**BEFORE THE PUBLIC UTILITY COMMISSION  
OF OREGON  
LC 73**

2019 Integrated Resource Plan Update

Staff's Comments

**Figure 1: PGE Annual MWH Sold, OPUC Stat Book**

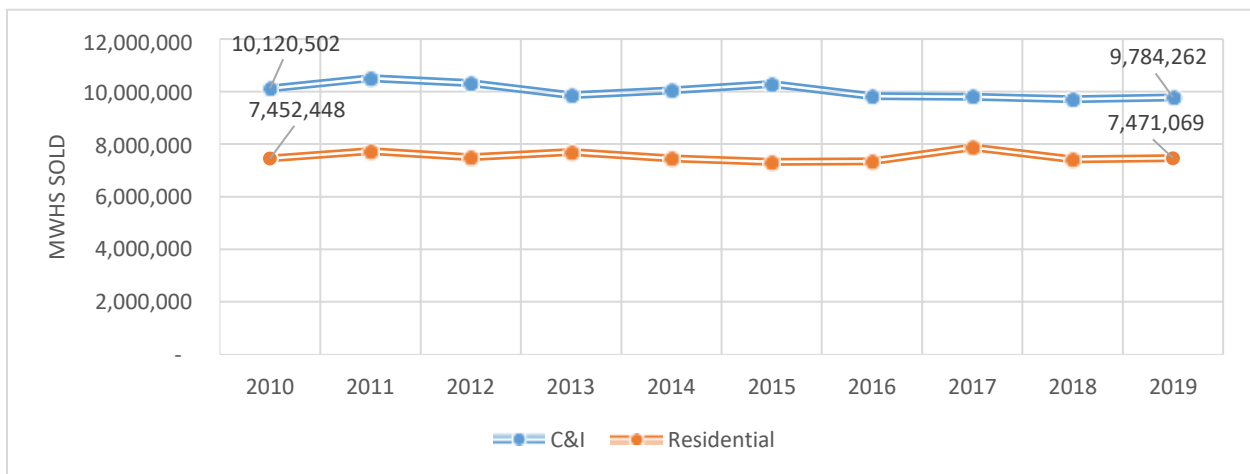
PGE’s IRP Update forecasts an increase in overall load growth from the acknowledged 2019 IRP. As shown in Figure 1, this increase is not necessarily in keeping with historic sales trends since 2010.

Staff looks forward to working with PGE between now and the 2022 IRP to better understand how recent developments have reversed historic trends in annual load growth.

**Figure 2: PGE Annual MWH Sold for Resale, OPUC Stat Book**

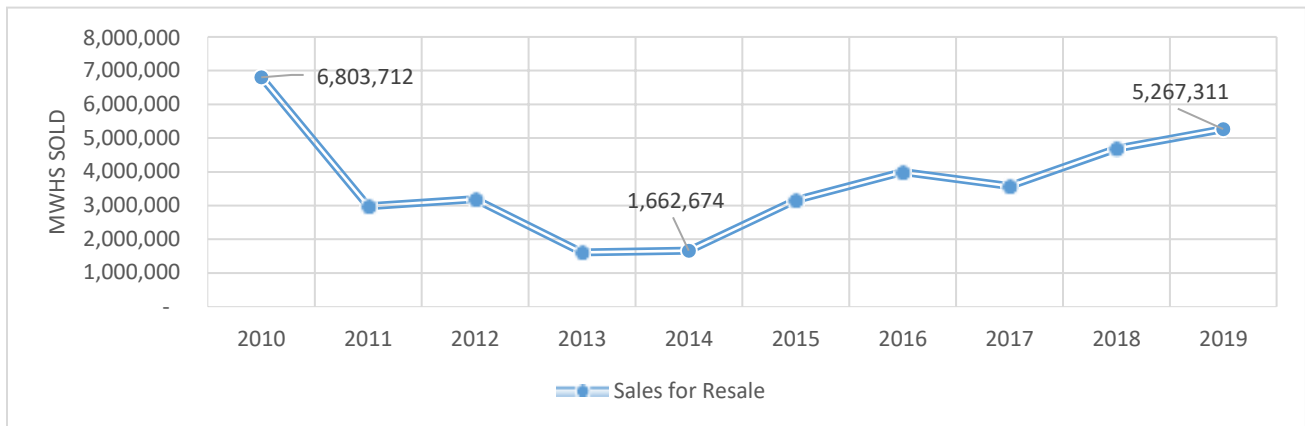
In PGE’s load forecast, related to capacity, in the 2050 reference case, summer peak demand increases by 124 MW due to the load forecast update.<sup>11</sup> Related to energy, PGE describes that, “in the outer years, the net market shortage increased, primarily due to the increased load forecast.”<sup>12</sup> Staff appreciates the clarifications in PGE’s response to DR 187 regarding the non-comparability of net market shortage in IRP planning and operational “sales for resale.” Regardless, as shown in Figure 2, the recent trend for PGE has been increasing sales to market.

Sales to market is only one part of an overall net position. Staff looks forward to working with PGE prior to the next IRP to understand the strategy and risks associated with resource acquisitions along with market purchases and sales to meet future load growth.

**Figure 3: Comparison of Summer On-Peak Market Capacity Assumptions**

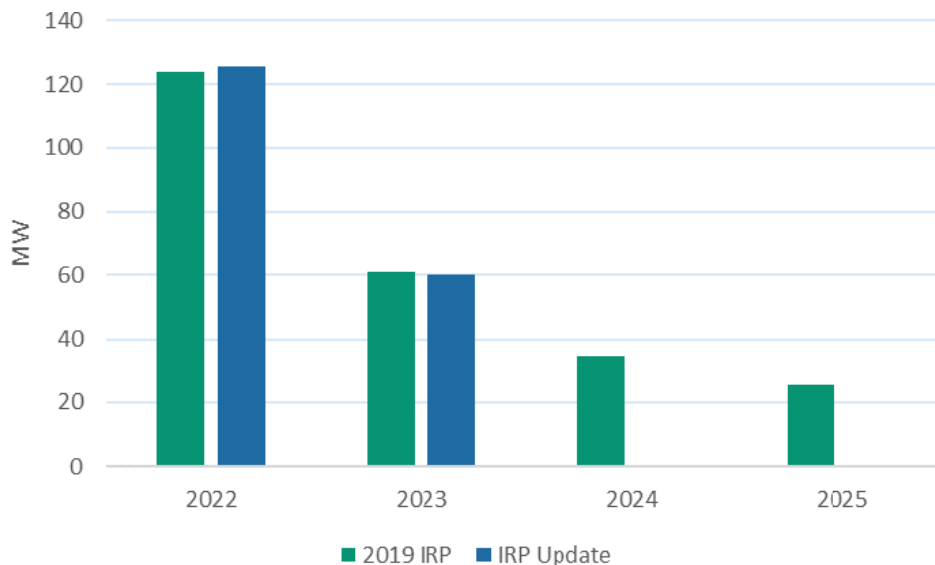
Figure 3, reproduced from IRP Update page 31, shows the decrease in summer, on-peak market capacity purchases available to PGE:

Staff’s IRP Final Comments recommended that “PGE should monitor and report on its market capacity assumptions as part of any RFP and in the 2021 update to LC 73, as market conditions may encourage the building of more generation resources regionally.”<sup>16</sup> Indeed, it appears that regional resource retirements have increased the regional need for capacity, especially in the summer.

**Figure 4: Comparison of Solar ELCC Curves**

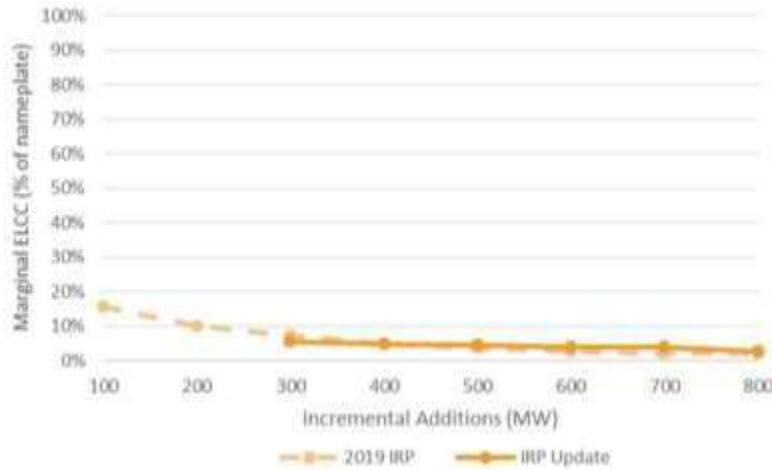
PGE has replaced its RECAP loss-of-load-probability model with the new Sequoia model that the Company developed internally. The Company uses its loss-of-load probability model to assess capacity need and to assign capacity contribution values to resources. Staff finds the Company’s process rationale for switching to the Sequoia model to reduce the need for outboard adjustments compelling. PGE also states that its Sequoia model introduces more sophisticated modeling of energy limited resources and interactive effects between resources. Simultaneous to the introduction of the Sequoia model, changes in the load and resource balance have changed capacity contributions. By running a baselining exercise, the Company has demonstrated that most of the changes in capacity contribution are due to the addition of similar resources on the system such that subsequent additions of resources with similar characteristics have decreased marginal benefits. For example, the declining marginal value of solar is shown as the downward sloping lines in Figure 4, which is reproduced from PGE’s response to Staff IR No. 189:

Only a small portion of the capacity contribution changes are attributable to the change from the RECAP model to the Sequoia model. Vetting the Sequoia model outputs is one of Staff’s top priorities for the next IRP. The ELCC values from the Sequoia model impact the avoided costs prices, so Staff is investigating the reasonableness of the ELCC changes. Broadly, this development is oddly juxtaposed to the IRP Update’s lack of on-peak summer market capacity in 2025. Staff looks forward to understanding the relationship, or lack thereof, between no summer, on-peak market capacity but a reduced ELCC – and thus capacity value – of new solar before the next IRP.

**Figure 5: Reference case Loss-of-load expectation heatmap for 2025**

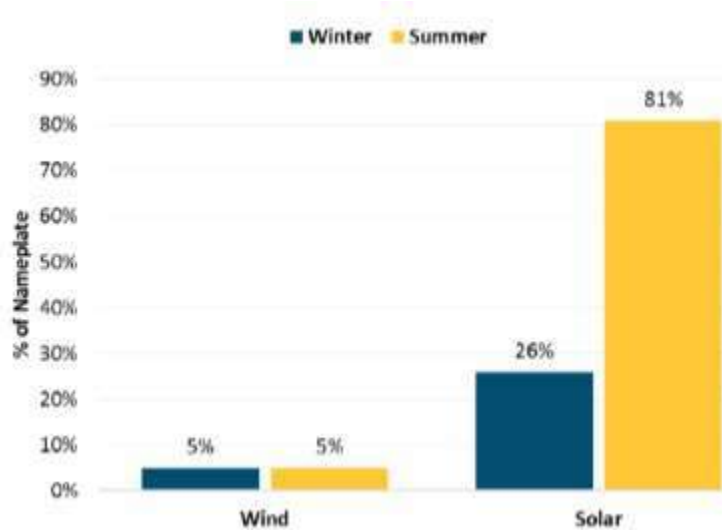
Staff is continuing to explore this change and appreciates that the Company provided Staff a narrative description of the capacity contribution changes in response to Staff IR 189. In Docket No. UM 2011, General Capacity Investigation, some stakeholders have expressed difficulty with the black-box nature of loss-of-load probability models like Sequoia. For example, visually looking at PGE’s updated loss-of-load expectation heatmap in Figure 5, reproduced from IRP Update page 36, shows that there remains visual expectations of loss-of-load during solar generation daylight hours:

PGE begins to justify the apparent visual usefulness of solar capacity in contrast to its low ELCC value by noting that “while the loss-of-load expectation heatmaps can be useful for understanding the hourly and seasonal nature of the probability of loss of load events, the heatmaps are limited in the information that they provide... the shading does not indicate information about the quantity of capacity needed.”<sup>20</sup> Nonetheless, Staff remains concerned as, for example, PGE’s computation is drastically lower than Consultant E3’s figure in IRP External Study E, which is reproduced as Figure 6 (E3’s study identifies the Northwest Power and Conservation Council as the source for the values):

**Figure 7: Mixed full clean action plan window resource additions**

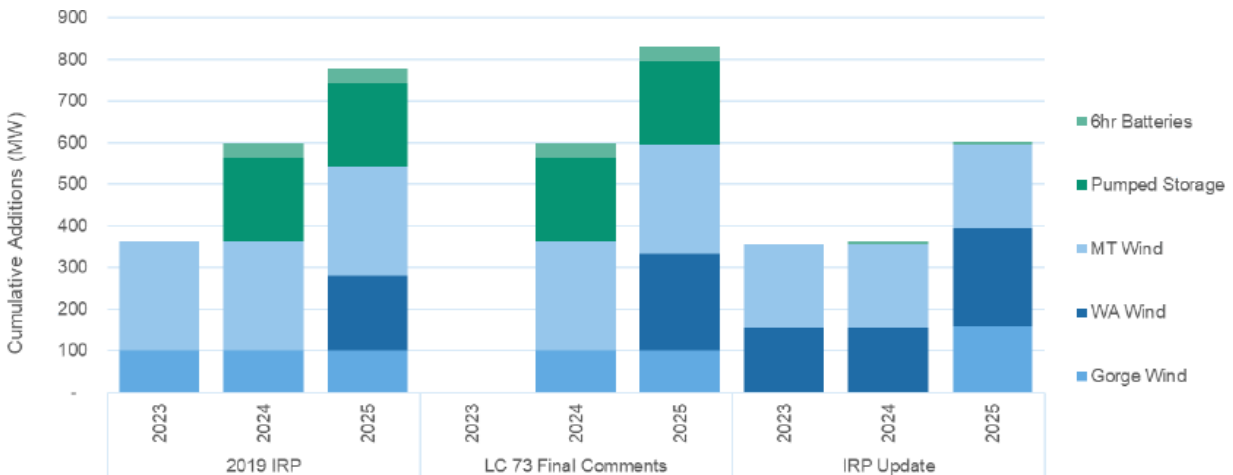
PGE’s preferred portfolio has significantly changed since its acknowledged IRP, as shown in Figure 7, which is reproduced from IRP Update page 52:

To understand the significant changes to the preferred portfolio, Staff met with PGE on February 23, 2021. PGE talked with Staff to provide an overview of the sensitivity of the preferred portfolio to production tax credit (PTC) changes. The significant change is to replace procurement of batteries and storage with wind in the near term. In an information request to PGE, Staff asked: if the PTC is extended again, is the optimal renewable addition delayed? In its response, PGE states that “the availability of the PTCs is an influential component in this determination [of the optimal type, size, and timing of all resource additions].”<sup>22</sup> Staff expresses a concern that because the ELCC of storage is greater than that of wind, the Company is obtaining less capacity per MW of nameplate resource size. Staff recommends that this issue be addressed in coordination with review of PGE’s RFP, specifically, if storage and battery bid prices are lower than assumed in PGE’s IRP, then procurement of storage and batteries might again become preferred. Staff is also concerned about the risk of potential future capacity shortfalls in the region. Staff is working to understand how PGE’s PPA with the Douglas County PUD affects the portfolio optimization.
